THE MARYLAND-NATIONAL CAPITAL PARK & PLANNING COMMISSION

MEMORANDUM

**REVIEW TYPE:** Site Plan Review  
**APPLYING FOR:** Approval of 44,000 new square feet of Commercial Space on 8.53 acres that includes 24,000 square feet Restaurant space, 15,000 square feet Casual Retail space, and 5,000 square feet Bank space with drive-through facility

**PROJECT NAME:** Westech Village Corner  
**CASE #:** 8-05022  
**REVIEW BASIS:** §59-C-18.132(d)(1):  
Site Plan Review required for any retail commercial development in the US29/Cherry Hill Road Employment Area Overlay Zone  
§59-C-18.132(b)(1)(4)(B): Waiver of maximum surface parking area requirement

Standard elevation as proposed for the Drive-through Bank (Building 1)

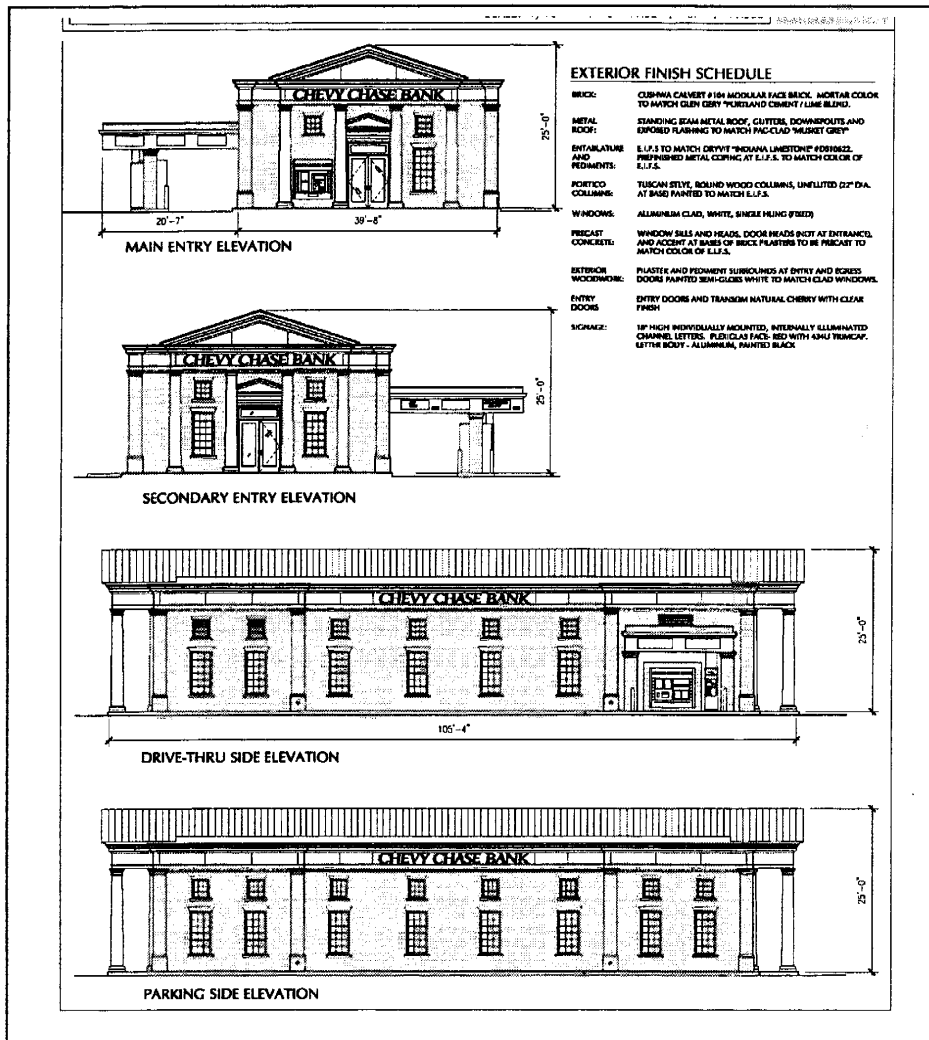
- a. Extend the area of special paving and brick banding northward along the side of Building 2 and along the side of Building 1 to enlarge the pedestrian refuge space and increase safety;
- b. Extend the area of special paving between Building 3 and Building 4;
- c. Extend the sidewalk connection leading to Prosperity Drive; provide 5-foot sidewalk on Prosperity Drive;
- d. Provide unified curb line for narrow landscape strip between landscape islands at head-in parking facing Buildings 2, 3, and 4 to increase pedestrian safety; plant intermittent hedges within the narrow landscape strip;
- e. Show a public access easement over the street edge sidewalk on Tech Road.
